APPLICATION NO.	FILING DATE	FIRST NAMED INVENTOR	ATTORNEY DOCKET NO.	CONFIRMATION NO.
10/828,942	04/21/2004	Isador H. Lieberman	CCF-6559NP	7200
26294 7590 01/19/2007 TAROLLI, SUNDHEIM, COVELL & TUMMINO L.L.P. 1300 EAST NINTH STREET, SUITE 1700			EXAMINER	
			ARAJ, MICHAEL J	
CLEVEVLAND, (	CLEVEVLAND, OH 44114		ART UNIT .	PAPER NUMBER
			3733	
SHORTENED STATUTORY PE	ERIOD OF RESPONSE	MAIL DATE	DELIVERY MODE	
3 MONTHS 01/19/2007		01/19/2007	PAPER

## **DETAILED ACTION**

Figure A

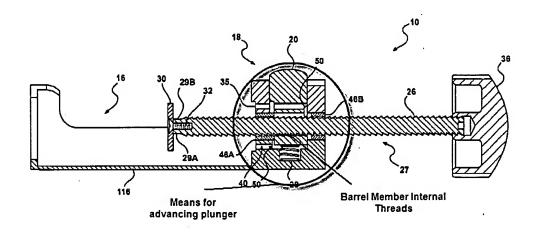
Claims 1-3, 6-9 and 12-15 are rejected under 35 U.S.C. 102(e) as being anticipated by Tague et al. (U.S. Patent No. 6,599,293).

Tague et al. disclose an apparatus comprising a barrel member (116) having an inner surface with internal threads (see Figure A below) with an exit port, a plunger member (27) disposed coaxially within the barrel member and a means for advancing the plunger member within the barrel member. The plunger member has a smooth outer surface (29B) and a helical pathway defined between the outer surface and the internal threads in the barrel member, whereby the bone graft material is guided though the barrel to the exit port along the pathway. The outer surface of the plunger has an outer diameter that is slightly less than the major diameter of the internal threads in the barrel member (see Fig 6A). The plunger member is rotable and includes external threads that are complimentary to and engaged with the internal threads in the barrel member. With regard the statement of intended use and other functional statements;
